Subject:	HOLDEN VT – VZ REPLACEMENT HEATER CORE (SQUARE CORNERED) CA527MIS OR HTR1365CH					TSB #:	29 3-10
						Date:	1/3/10
Initial Once Read:

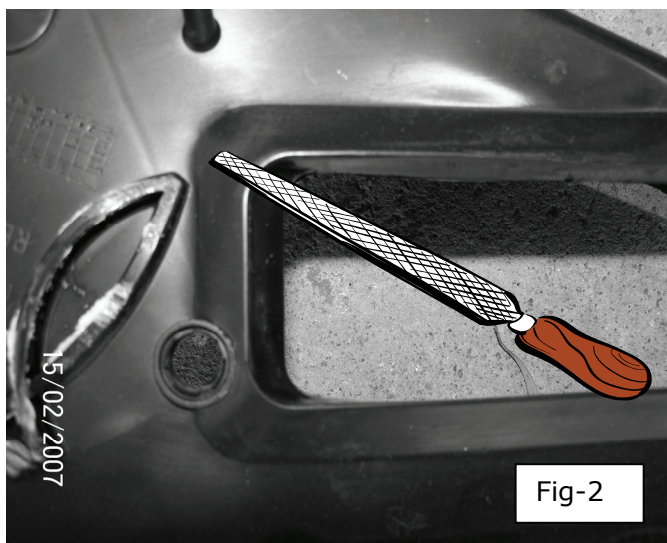
- Using a square file, square off the 4 corners of the heater case opening to enlarge the opening for the replacement heater core.
- Install the replacement heater core ensuring adequate clearance via the modification. Comparison of the square and rounded header tanks in fig -1.

Figure -2. Heater core opening with rounded corners.

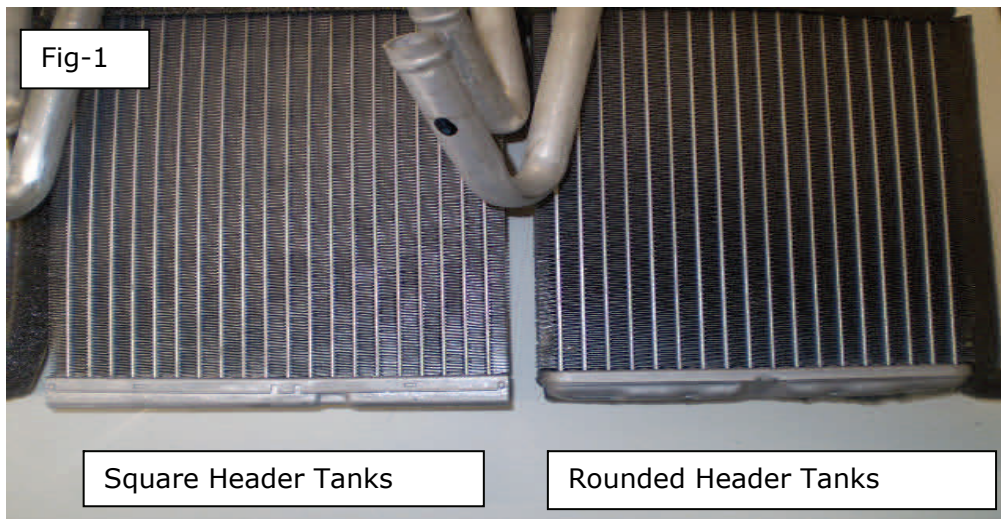
Carry out inspection of the HVAC heater core opening to determine if the case requires modification. If fitting a new heater core with the square header tanks the heater core opening of the HVAC will have to be modified if the opening has rounded corners. To modify the heater core opening refer to procedure below. *

To fit the heater core with the square header tanks file the corners of the opening.
